City of Portland, Maine - Building or Use Permit Application

Permit No: 01-0932	Issue Date: AUG - 3 2001	EBL: 057 D035001
-----------------------	-----------------------------	---------------------

Proposed Project Description:  
Replace front Stairs and rear Deck

Re: Porch and Deck Reconstruction – 81 Gray Street

PROPOSED DECK TO REPLACE EXISTING DECK

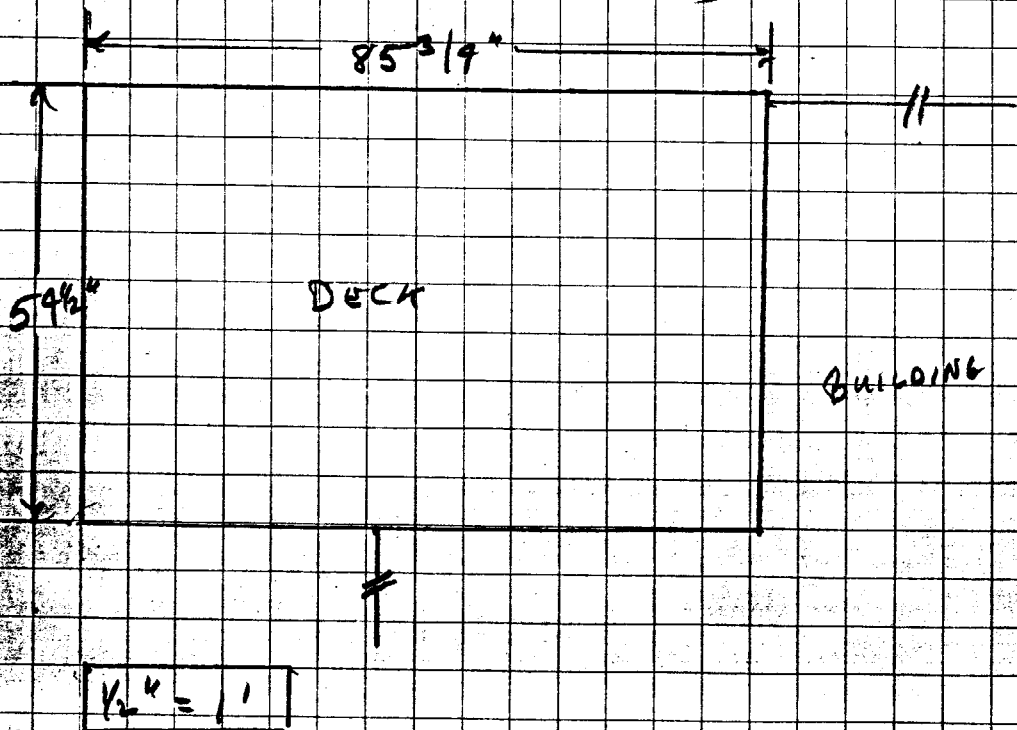
- X 38. Historic Preservation shall approved these proposed stairs and deck before work is started.
- #39 This is not an approval to add another unit.
